*Application No. 10/758,202*  
*Amendment dated November 22, 2005*  
*Reply to Office Action of May 23, 2005*

*Docket No. 0051-0218P*  
*Art Unit: 3654*  
*Page 7 of 13*

**AMENDMENTS TO THE DRAWINGS**

**REMARKS**

FIG. 2

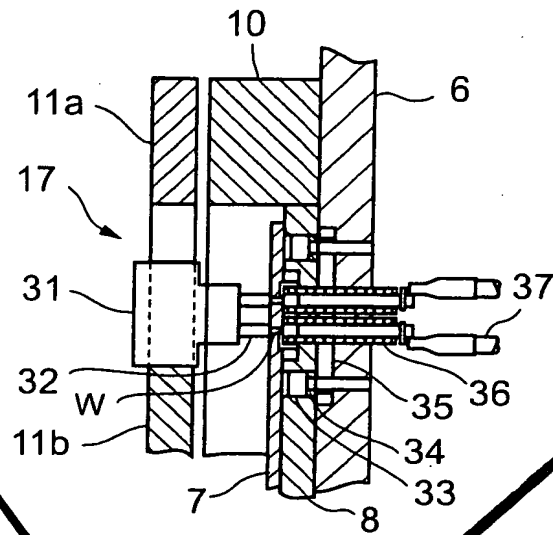
Two (2) sheets of replacement drawings are attached hereto in order to properly label sorting and ejection part 12 and inspection unit 31 in FIG. 2, and to properly show clamp bar 35 and slide groove 35a in FIGS. 11, 12(a), and 12 (b). The two sheets of replacement drawings attached hereto replace Figs. 2, 11, 12(a) and 12(b) as originally filed.

Two sheets of replacement drawings are attached hereto in order to properly label sorting and ejection part 12 and inspection unit 31 in FIG. 2, and to properly show clamp bar 35 and slide groove 35a in FIGS. 11, 12(a), and 12 (b). No new matter has been entered.

FIG. 11

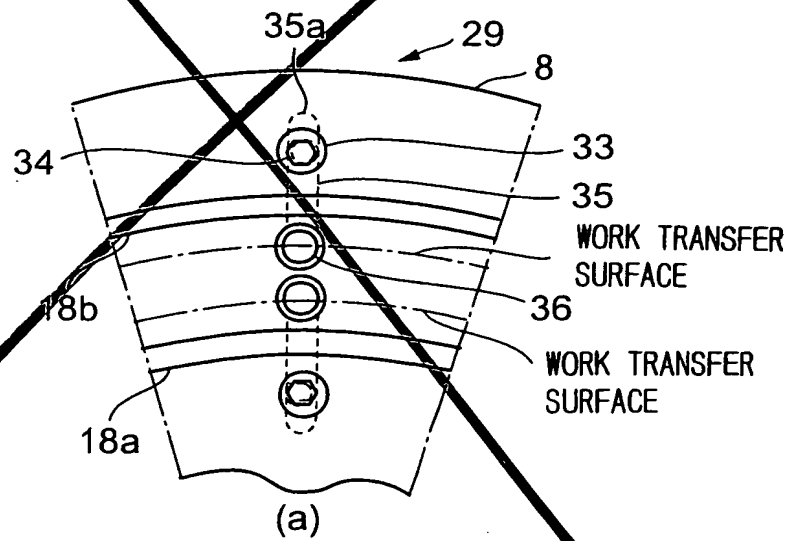
Also, in the interview, the Examiners pointed out that they believed that FIGS 11, 12(a), and 12(b), as originally filed, do not clearly show clamp bar 35 and slide groove 35a. In particular, the Examiners alleged that in the drawings, elements 35 and 35a appear to have the same length, and thus it is hard to tell how clamp bar 35 can slide in slide groove 35a. In response to this objection, revised FIGS. 11, 12(a), and 12 (b) are attached hereto to properly show clamp bar 35 and slide groove 35a, and their relationship to one another.

As is apparent from replacement FIGS. 11, 12(a) and 12(b) the slide groove 35a is longer than the clamp bar 35, and therefore the clamp bar 35 can securely slide in the slide groove when the eccentric cam 34 is rotated.

As is apparent from revised FIGS. 11, 12(a) and 12(b) the slide groove 35a is longer than the clamp bar 35, and therefore the clamp bar 35 can securely slide in the slide groove when the eccentric cam 34 is rotated.
